Central Planning Authority

Agenda for a meeting of the Central Planning Authority to be held on **June 21, 2023 at 10:00am in Conference Room 1038, 1st Floor, Government Administration Building, and Elgin Avenue.**

CPA/14/23

Figure 1: Extent of this application overlaid on aerial imagery. Note the application is limited to only a small portion of 12D108 (Source: Submitted Plans [Job# 0922, DWG A2], Aerial Imagery Source: UKHO, 2021)

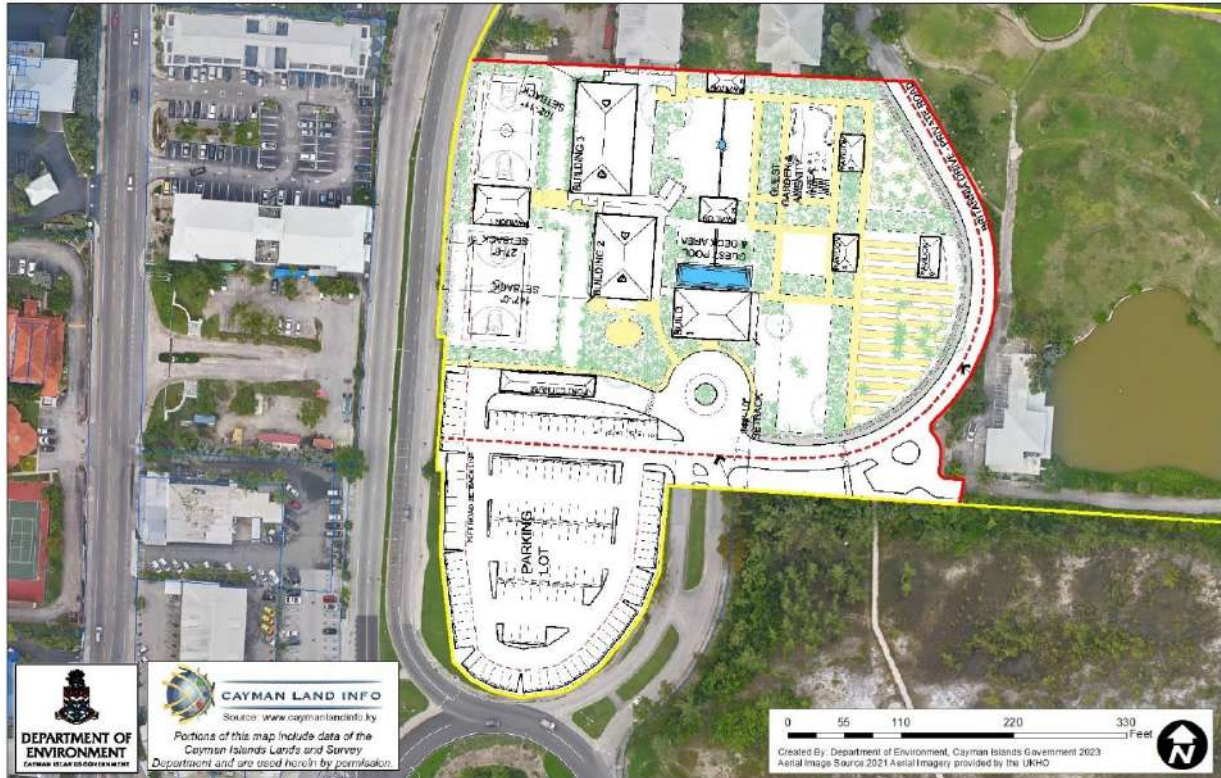
The application site is man-modified, having been developed for a hotel / golf course circa 1990. The main hotel ceased to operate following Hurricane Ivan in 2004 and has been unused since. The proposed redevelopment is currently limited to the south west corner of the wider site (refer to Figure 1).

The site plan incorporates a significant amount of landscaping space. We highly recommend that native plants are incorporated into the landscaping scheme. We do note that some have been included within the landscaping palette in addition to non-native horticultural species. Native plants are best suited for the conditions of the site, including the temperature and amount of rainfall. They are climate appropriate and require less maintenance and irrigation. Landscaping with native vegetation also provides ecological benefits by creating habitat and food for native fauna such as birds and butterflies, promoting biodiversity and providing valuable ecosystem services. Native plants are also part of the identity of the Cayman Islands and can be used for placemaking and to distinguish Cayman from other places and therefore are particularly important to include in tourist facilities.

Figure 1: LIS 2018 aerial imagery with the outline of the proposed new buildings from the Applicant’s site plan overlaid. Green sea turtle nests are shown in green and Loggerhead turtle nests are shown in orange. The red line delineates the designated critical sea turtle habitat.

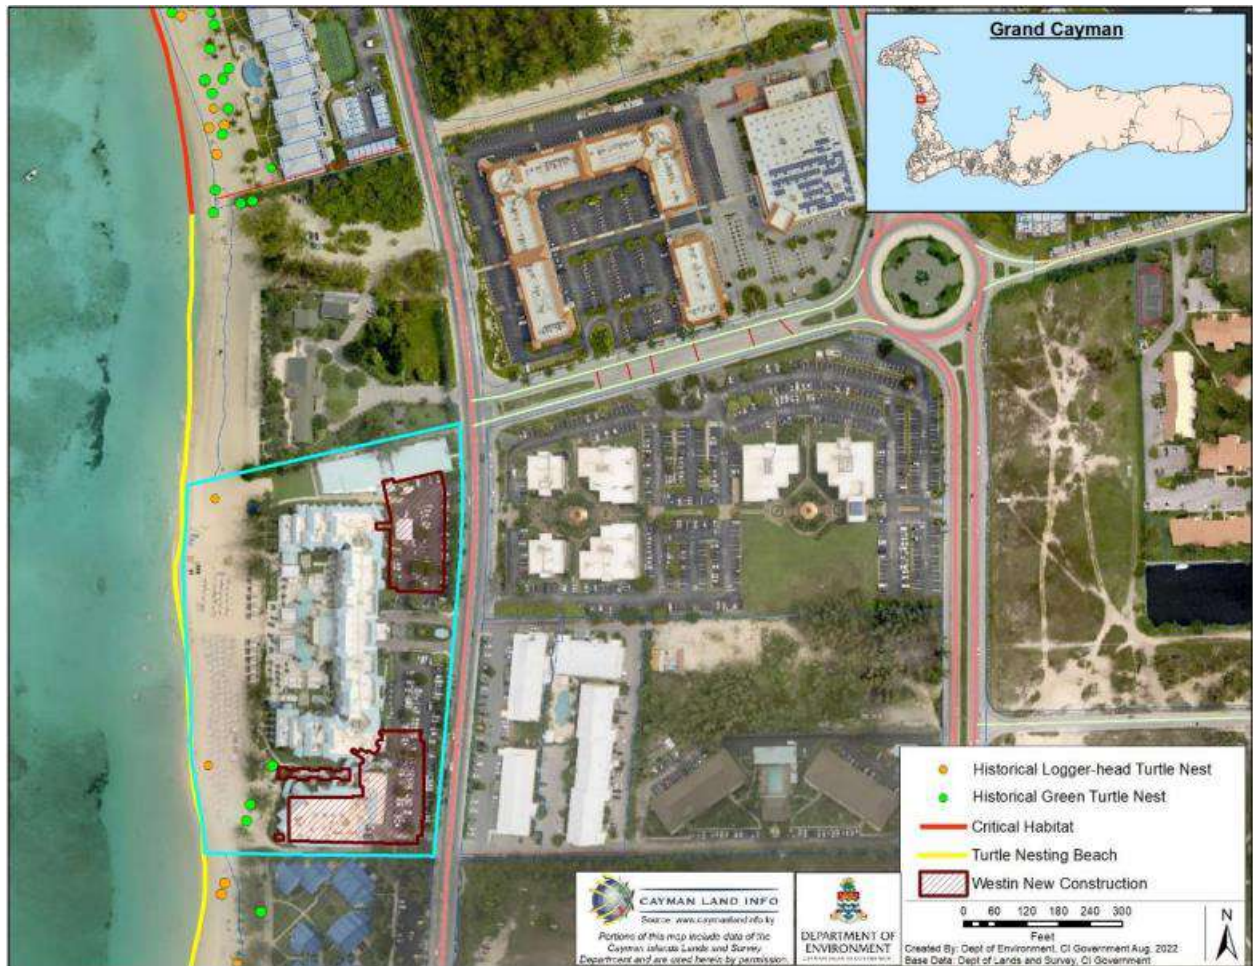
from the artificial lighting which directly illuminates the nesting beach. The Applicant has not indicated the use of turtle friendly lighting in the proposed development. Historical nesting on the site has been concentrated to the south (see Figure 1). Currently, a low-level restaurant building occupies the southern section of the resort. With the construction of the proposed 10-storey hotel tower, the impacts of artificial lighting on the historical nesting area of the beach are likely to be amplified due to the cumulative increase in lighting.

Figure 14: Digital Terrain Model (DTM) for the application site. The higher areas of the site are indicated in red and orange and show the beach ridge and sand reserves within the site.

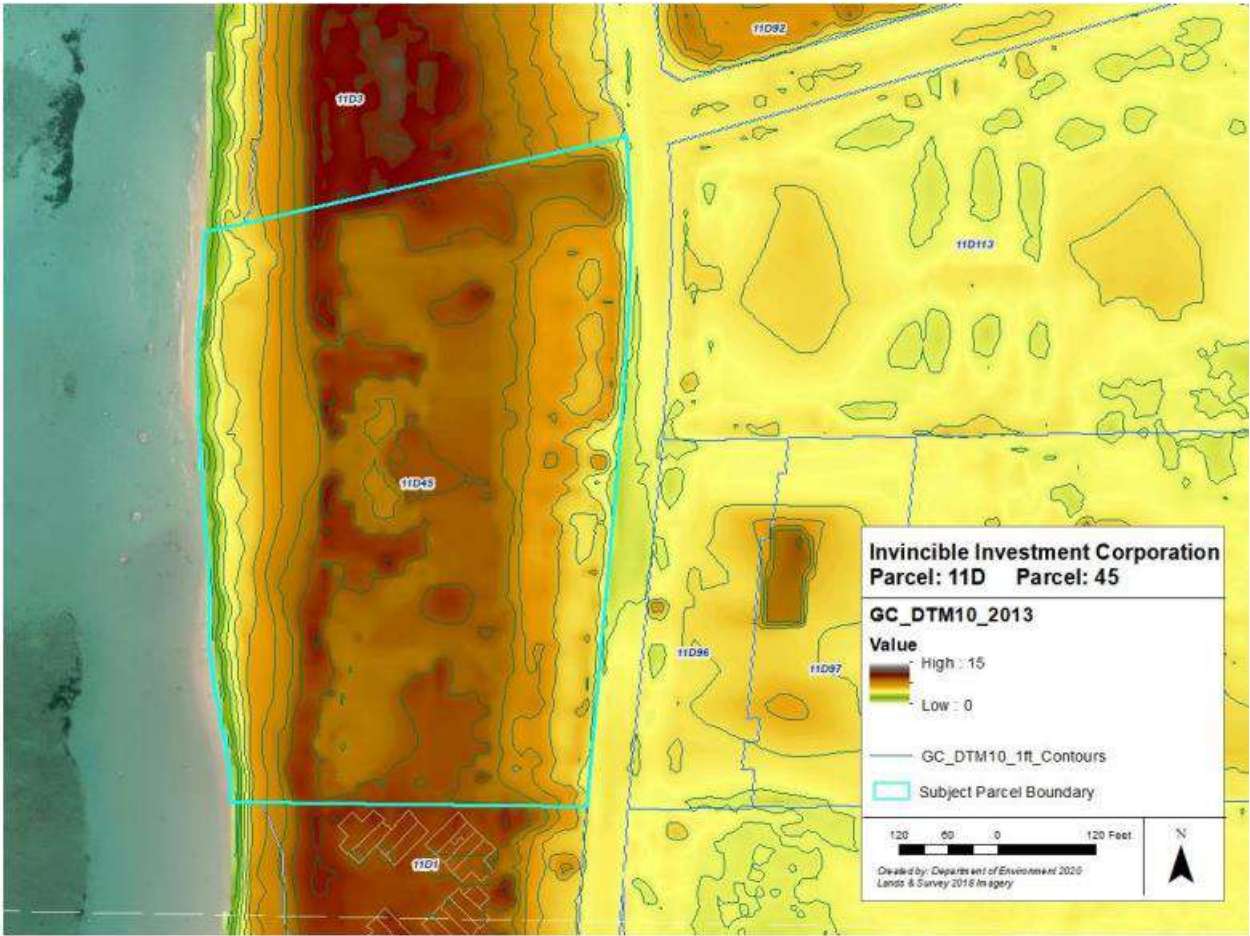
Although the subject parcel is predominantly man-modified, it still consists of massive sand reserves as shown in Figure 14 and the removal of these reserves is a concern. The reserves are important to the resilience of the beach system and are a natural source of sand which replenishes the beach profile after major storms. A significant amount of sand may result from the excavation of the foundations and pool. Once excavated and removed from the beach system, these sand reserves can never be recovered, making the beach system increasingly more vulnerable to erosion, which is exacerbated by the impacts of climate change, especially sea-level rise. We recommend that any excavated sand is kept on-site and placed landward of the High-Water Mark to retain sand reserves and create depth in the beach profile.

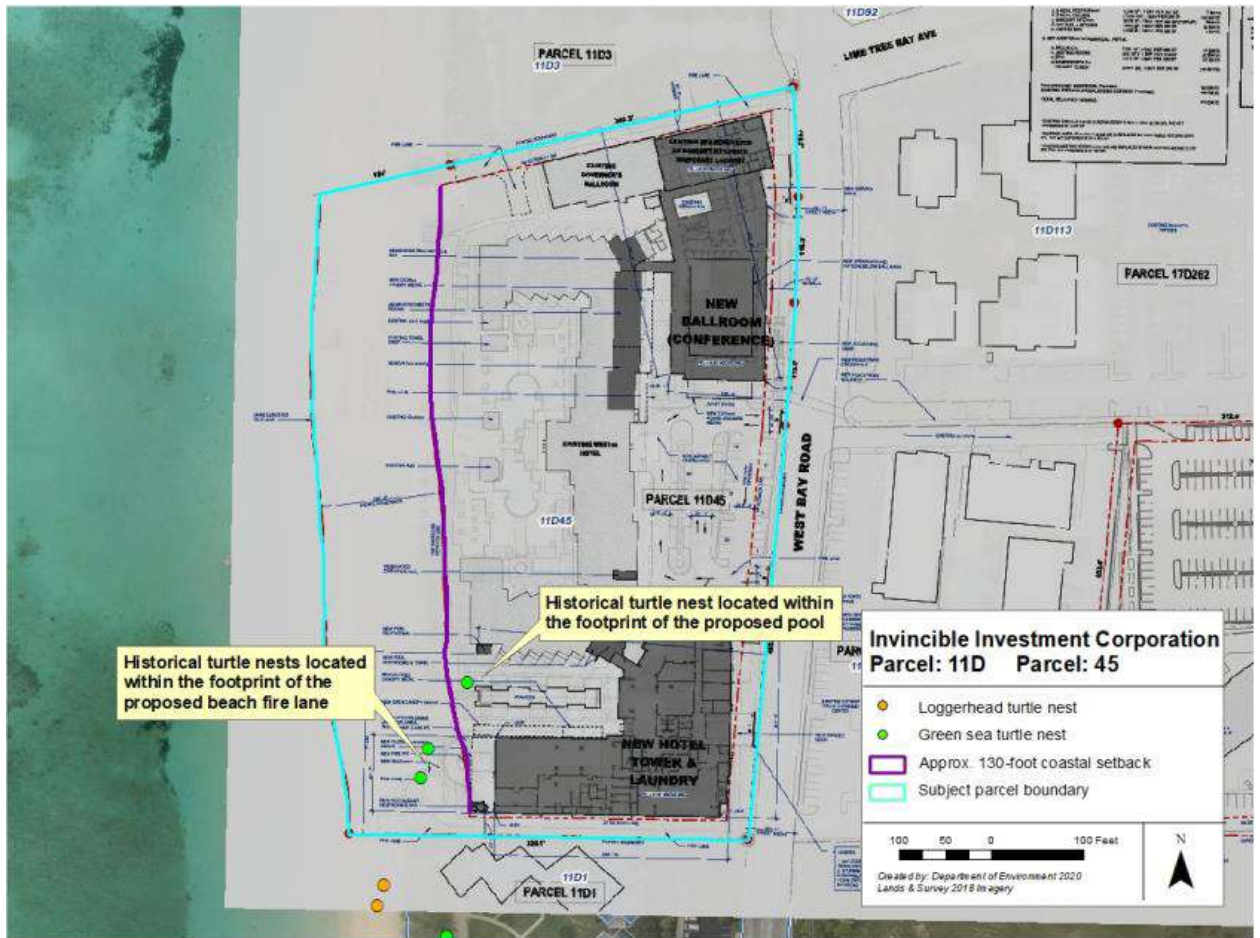
The Applicant has not requested any variances to the Development and Planning Regulations coastal setbacks, however, as shown in Figure 2, portions of the proposed pool deck, the proposed outdoor seating area and the proposed fire lane are all located within the 130-foot setback from the Mean High Water Mark. These areas of the proposed development also have historical turtle nests located within their footprints. Hard structures located within the 130-foot setback e.g. the fire lane on the beach, decrease the size of the potential turtle nesting habitat.

Figure 3: Location of the application site and neighbours. The image illustrates the similar coastal setbacks of the application site (circled in red) and the properties to the north and south.

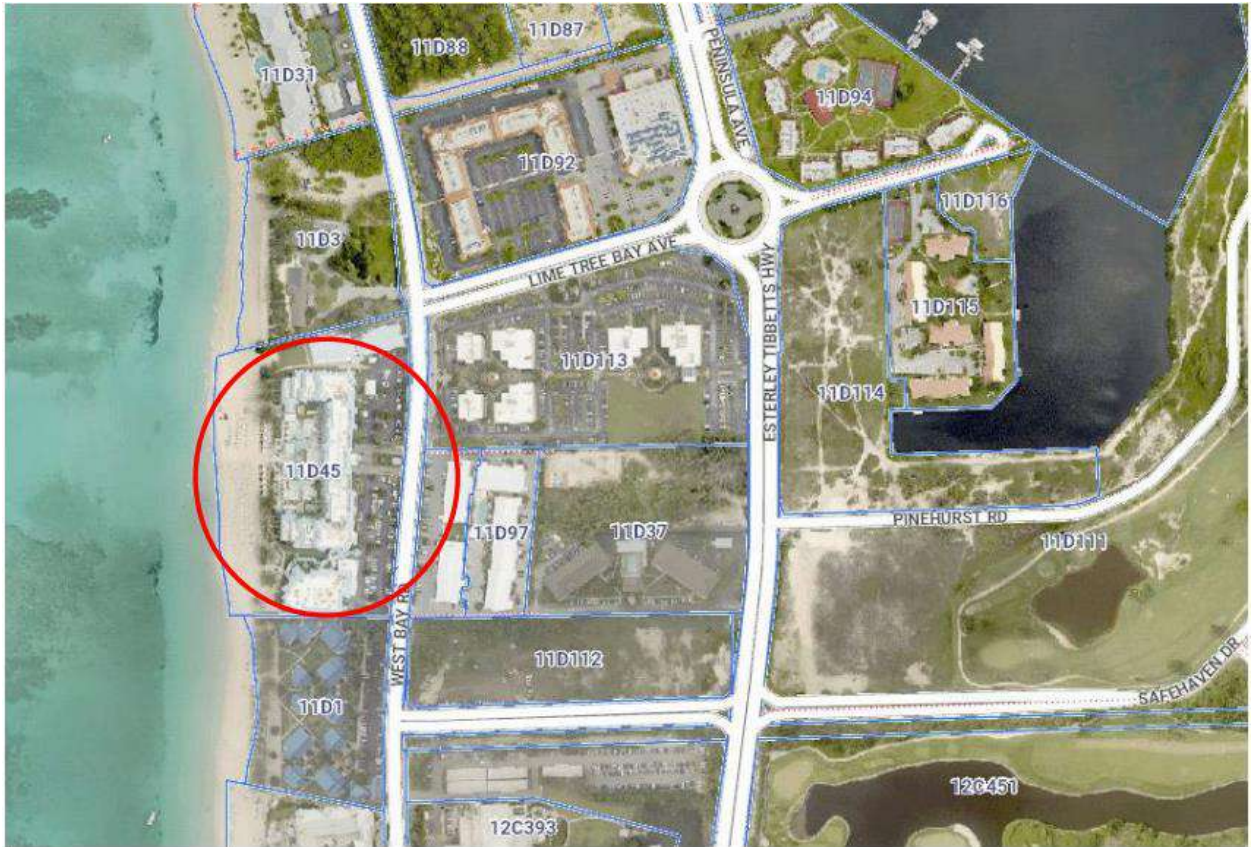
The proposed development will be set back 20 feet from the northern and southern parcel boundaries. The neighbouring property to the north (The Governor's House) is located a little over 20 feet from their southern boundary. The southern neighbouring property's (Villas of the Galleon) northern side setback ranges from 8 feet to 14 feet. The application site and the neighbouring properties to the north and south all have a similar setback from the Mean High-Water Mark ranging from 120-160 feet (see Figure 3).

With the demolition of the southern single-storey building and the construction of a 10-storey hotel tower in its place, even if repositioned to comply with the minimum required setback under the Development and Planning Regulations, it will be very visually prominent on the beach. When the proposed 10-storey hotel tower is constructed it may block daylight, sunlight and views from the northern units of the neighbouring residential property to the south (Villas of the Galleon) (see Figure 4).

Figure 1: Topography of South Sound drainage basin (outlined in red) and location of proposed road (outlined in yellow)

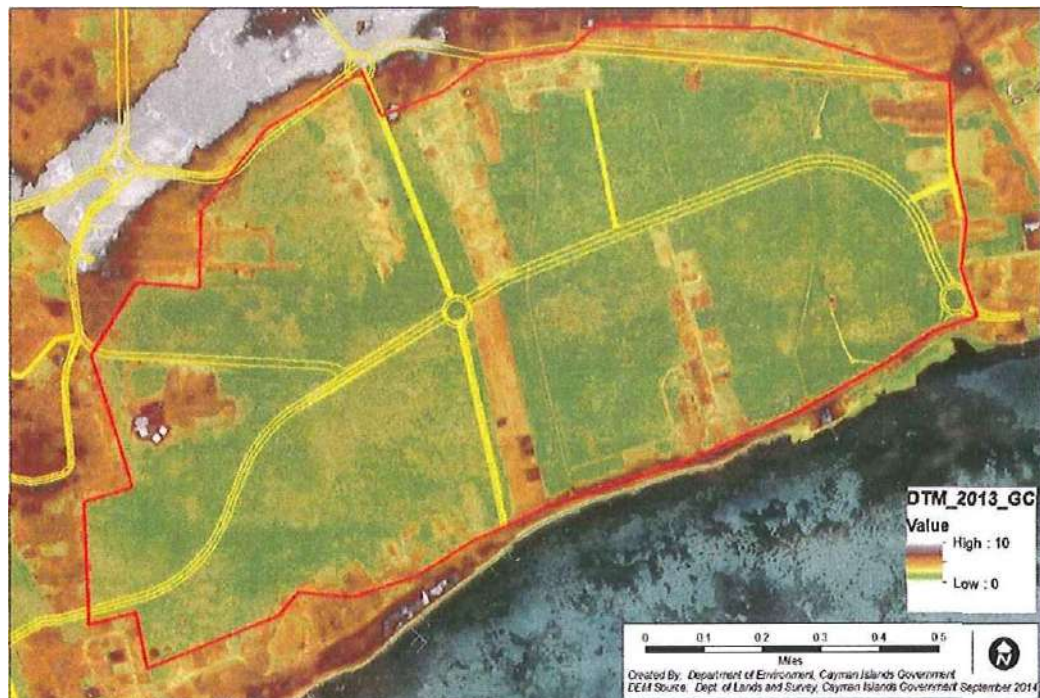
Proposed and existing developments including new roads in the South Sound drainage basin are shown in Figure 1 and Figure 2.
